# BGA TECHNICAL COMMITTEE

## TECHNICAL NEWSHEET 3/4/00

TNS 3/4/00

## OLYMPIA 2B. BGA909.

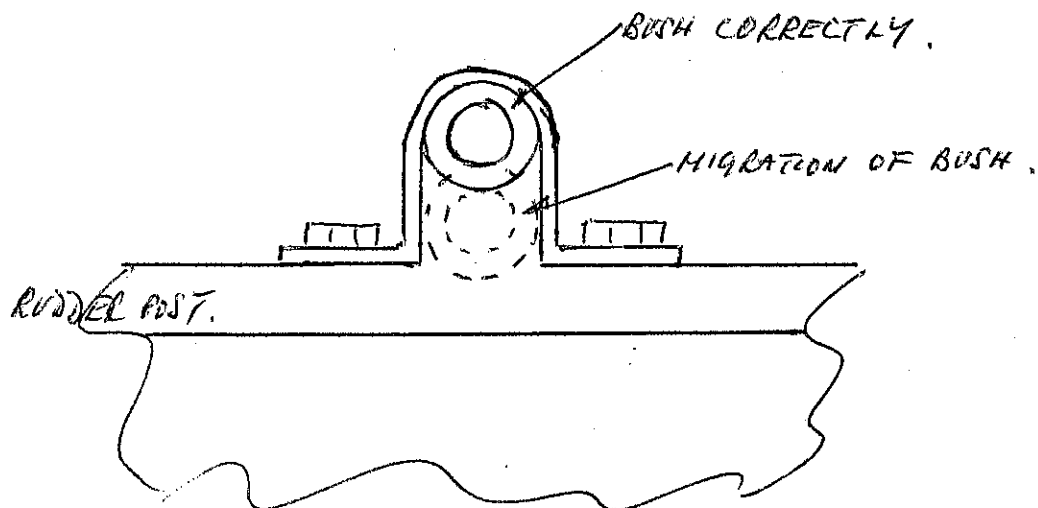
Fault found on rudder during annual C of A inspection.

Play at lower hinge suggested worn bush, however removal of the lower hinge capping revealed a more serious fault.

The bush which is normally retained in the 'U' shaped saddle by a weld top and bottom had come loose and moved rearwards by approx. 5 m/m, impacting on the rudder post. (At this stage it was thought that pilots pressing on both pedals together could have caused this to occur.!) )

The rudder was removed and as the old bush was worn a new one was securely fitted.

The three hinge pins attached to the stern post were checked for correct alignment and the rudder offered up for refitting and at this stage it was found that the three bushes/saddles were not in alignment.

The centre saddle (which already had a packing block attached) was removed and a new packing block made up 1.5m/m thicker and then refitted.

Subsequently the rudder fitted correctly without mis-alignment.

**Subject:** Bearings in the control stick

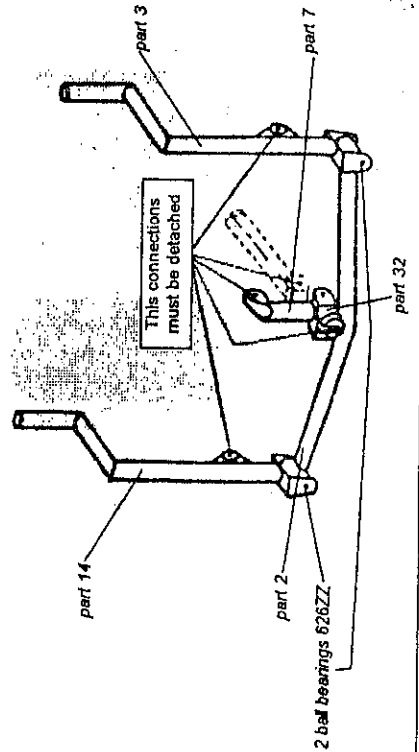
The spheric slide bearings GE 8 E according to TM 653-47 wear out very soon and are no longer obtainable.  
If these spheric slide bearings must be replaced, the complete control column (Parts 2, 3, 7 and 14 according to 653E-41-S10 and part 32 according to 653E-41-S10E1) must be modified according to 653E-41-S10 change d.

New slide bearing supports must be welded to the parts 2, 3, 7 und 14 (see below sketch) according to 653E-41-S10 change d and 653E-41-S10E1.  
The old Part 33 of 653E-41-S10 located between part 2 and 7 is to be replaced by the new part 32 according to 653E-41-S10E1.  
With the exception of the spheric ball bearing 14 C 8 at part 2 of 653-41-S10E1 all the other bearings are spheric slide bearings (1x SSCP 8 IH und 2x SSCP 6 IH). All the slide bearings are fixed with Loctite 270. Apply 2 new chime rings at each bearing.  
Replace the additional 4 ball bearings 626 ZZ at part 2 of 653E-41-S10.
